MIL-I-18804B

Amendment-1

MILITARY SPECIFICATION

INDICATOR. VERTICAL SPEED, 0-6000 FPM, 2-INCH

FIGURE 2. DIAL MARKINGS FOR MS28075-1 (B) and MS28075-2 (B)

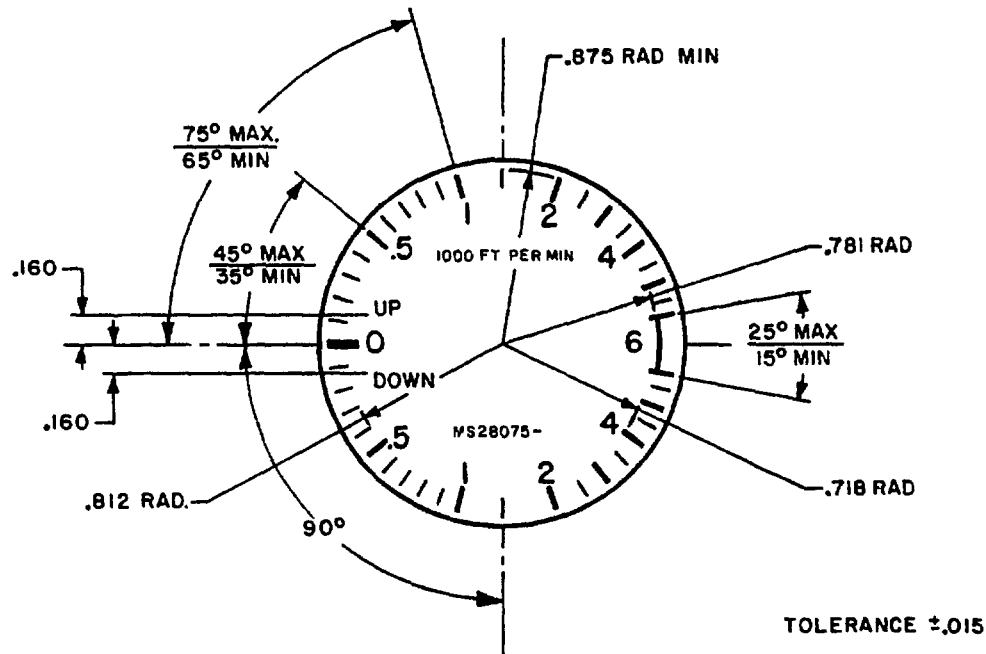
Add Figure 2 "Dial Markings for MS28075-1(B) and MS28075-2(B)" after Figure 1, page 6. Figure 2 forms page 3 of this Amendment.

Page 9, paragraph 4.6.7.1: Delete fourth sentence and substitute "The pointer shall return to zero within 250 FPM in both directions for the Figure 1 dial, and within 150 FPM in both directions for the Figure 2 dial".
